Subject: Withdraw and re-application of PCN at Power Diode - No.4023001 and 4023002 PCN to be replaced with No.4023003 and.4023003 PCN

Notification of Product/Process Change

Title of change	Additional approval request for PMDU(M) <SOD-123FL> production at China (Tianjin) factory		
Affected product(s)	Manufacturer part number		Customer part number
	PMDU(M) <SOD-123FL> package diode products (refer attached sheet)		
Detailed description of change	Now		After
	Production Factory (Assembly) : Japan, Malaysia		Production Factory (Assembly) : Japan, Malaysia, China (Tianjin)
Reason for change	ROHM will enhance its Business Continuity Management and respond to the increasing demand by introducing its China (Tianjin) factory as an additional site for the PMDU(M) <SOD-123FL> package production.		
Anticipated impact on quality	Same quality as made in Japan and Malaysia. (refer to the 4M document)		
Identification of change	Identifiable by the dot mark on the surface of the product.		
Planned first ship date :		May 6, 2023	Sample available schedule : Within 6 weeks from request
Attachments (data, report)		none 4M 4023002-2_4ME	R1b1 4023002-3_R1b1

Additional approval request for PMDTM 〈SOD-1

Outline comparison

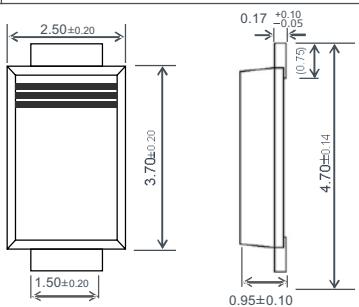
Package type	PMDTM (SOD-128)		
Production plant	ROHM Wako Co.,Ltd.	ROHM-Wako Electronics (Malaysia) Sdn. Bhd.	ROHM Semiconductor (China) Co.,Ltd.
Production site	Japan (Okayama)	Malaysia	China (Tianjin)
Dimension	No change		
Footprint reference	No change		
Lead finish	No change Electro plating : Sn 100%		
Marking method	No change Scan laser marking:30dots.		
Internal structure	No change Non wire (Solder joint) type		
Molding compound	No change Halogen Free		
Internal chip	No changes		
Maximum absolute rating	No changes		
Electrical characteristic	No changes

No change in product specifications.

Dimension and Footprint

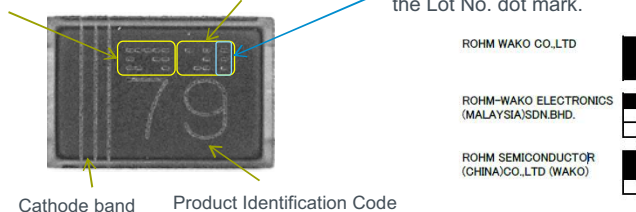
Package type	PMDTM (SOD-128)		
Production plant	ROHM Wako Co.,Ltd.	ROHM-Wako Electronics (Malaysia) Sdn. Bhd.	ROHM Semiconductor (China) Co.,Ltd.
Production site	Japan (Okayama)	Malaysia	China (Tianjin)
Dimensions	 <p style="text-align: right;">Unit:mm</p> <p style="text-align: right; color: blue; font-weight: bold;">No Change</p>		
Footprint reference	 <p style="text-align: right;">Unit:mm</p> <p style="text-align: right; color: blue; font-weight: bold;">No Change</p>

No change in external dimensions and footprint reference.
